MY1 FINAL MONITORING REPORT
Hornpipe Branch Tributaries Mitigation Project
Lenoir County
Neuse River Basin
CU 03020202

DMS Project # 100076
DMS Contract # 7605
Contracted RFP # 16-007401
USACE Action ID Number: SAW-2018-01762
DWR Project # 2018-1155

RE: WLS Responses to NCDEQ DMS Review Comments for Task 7 Draft Monitoring Report Year 1 for Hornpipe Branch Tributaries Mitigation Project, NCDEQ DMS Full-Delivery Project ID #100076, Contract #7605, Neuse River Basin, Cataloging Unit 03020202, Lenoir County, NC

Crest Gauge Data – Hornpipe Branch Tributaries MY1

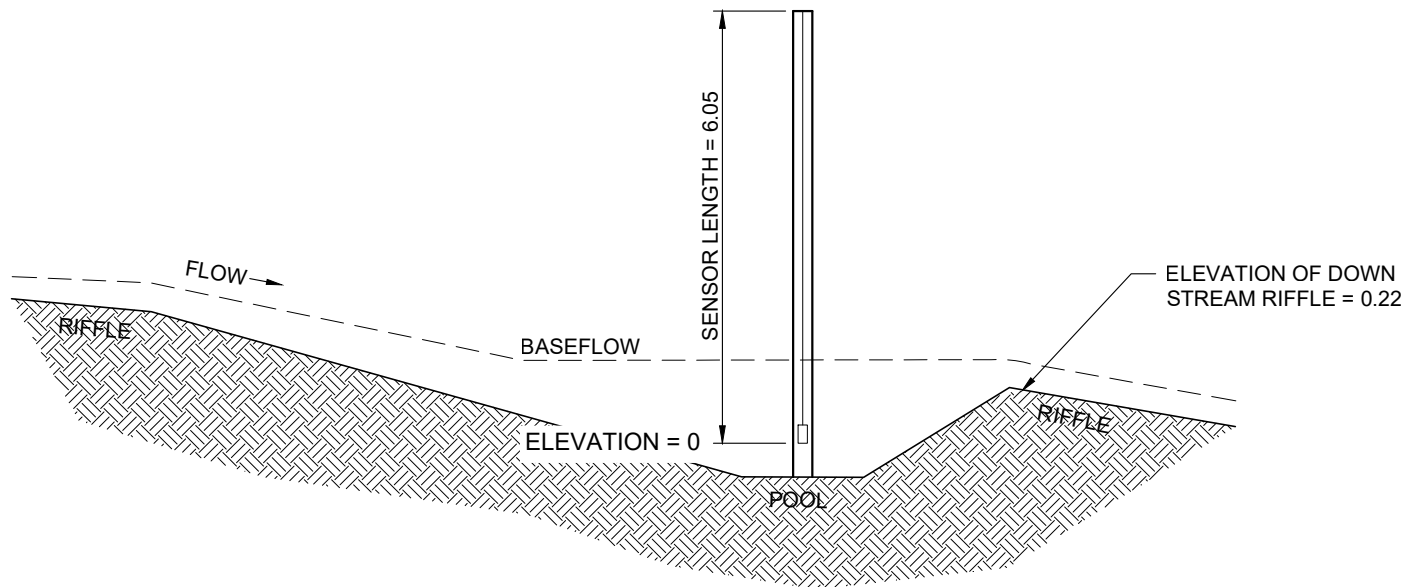
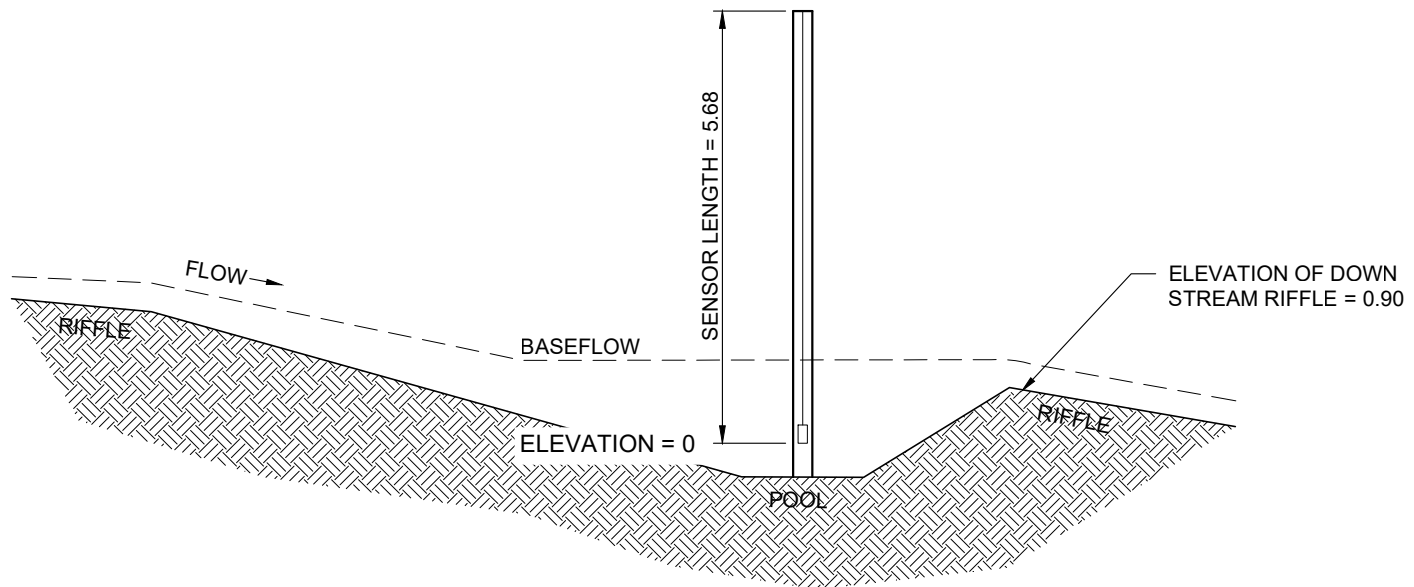
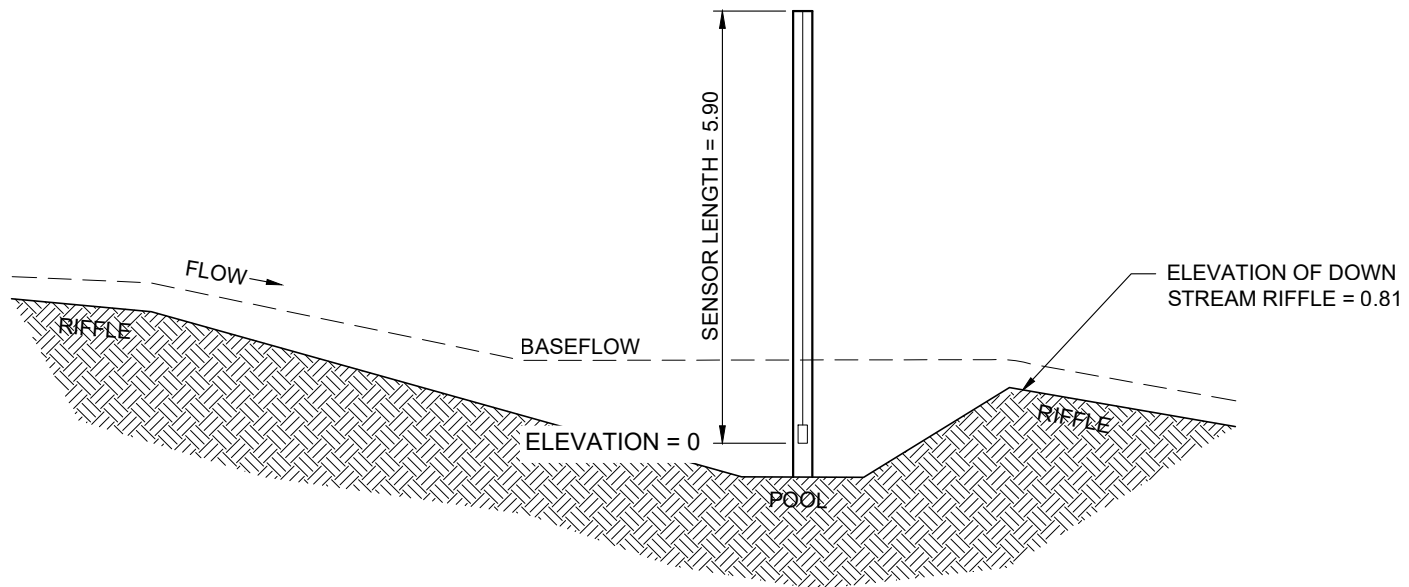
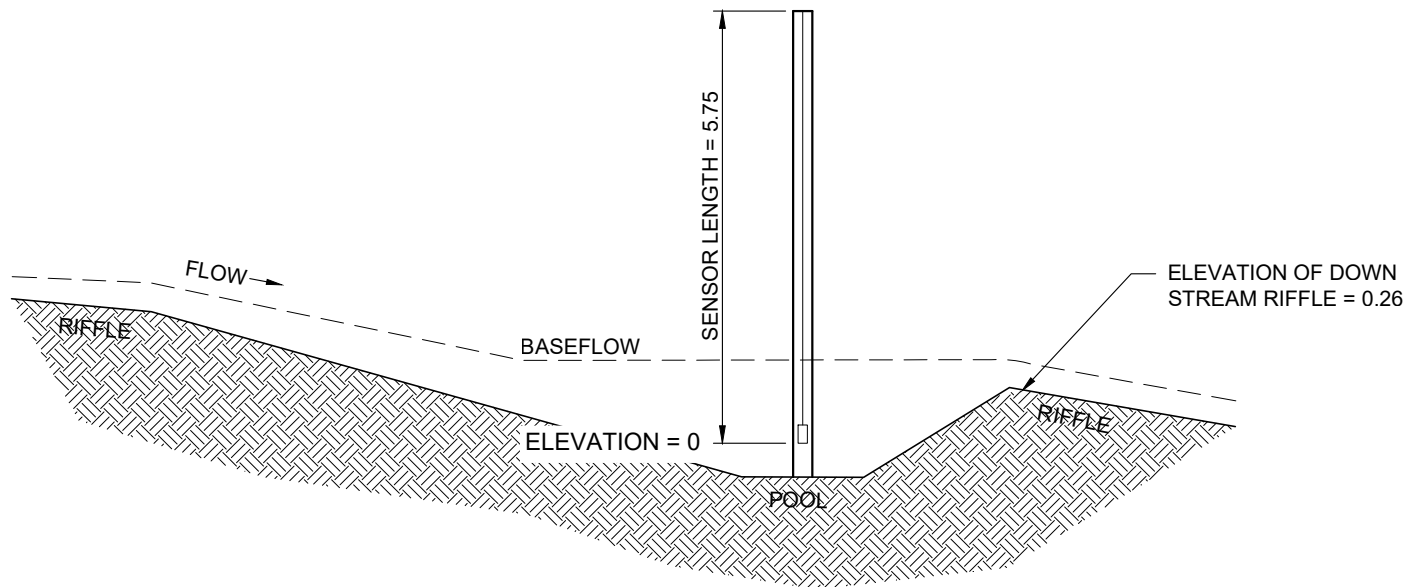
- 4. DMS Comment: Note that the symbology used for the Bankfull Depth and Downstream Riffle lines are switched between the FG and CG figures.** Response: Symbology on the graphs has been changed to be consistent on gauge figures.
